October 19, 2010

TO: Ed Venable, Manager, Engineering and Stormwater Division, City of Durham  
 FROM: Alan Dippy, Chair, Durham Bicycle and Pedestrian Advisory Commission  
 Subj: Swing Gates on Phase E of American Tobacco Trail

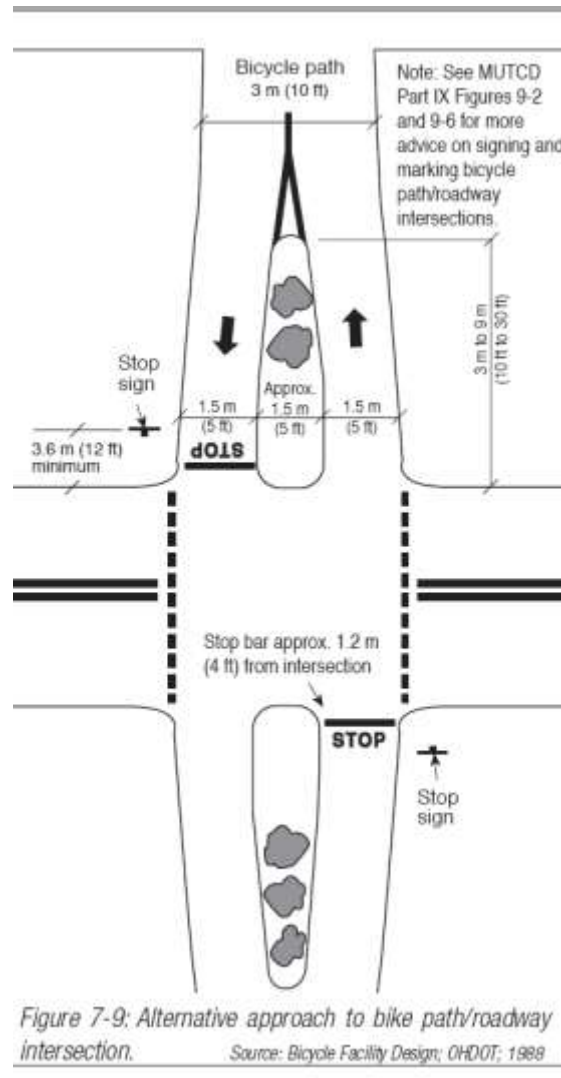
There is one design element, however, that gives us some concern. We have learned that swing gates may be used at the intersections with Massey Chapel Road and Scott King Road. According to drawings we've seen, there would be one 3' wide opening to the side of the gate where bicycle and pedestrian traffic would pass through. According to NCDOT's Bicycle Facilities Planning and Design Guidelines, there should be a minimum of 5' clearance between bollards or inset posts. See Figure 7-8 below:

Though a 3' clearance is acceptable for a single pedestrian or standard upright bicycle, it would be difficult for cyclists hauling trailers or tri-cycles to negotiate this opening.

Our recommendation would be to maintain the same intersection design with bollards that will be used for other roadway crossings in Phase E. These would be more consistent with what has been done on Phases A-D of the trail and allow bi-directional traffic flow at the intersections. Another possible treatment would be bi-furcated openings, as shown below in Figure 7-9 of the Guidelines. This has been utilized at a trail entrance in Carrboro (at the intersection of Greensboro Street and Estes Drive). This design requires no gates or bollards, yet the narrowness of the paths dissuades entry by motorists.
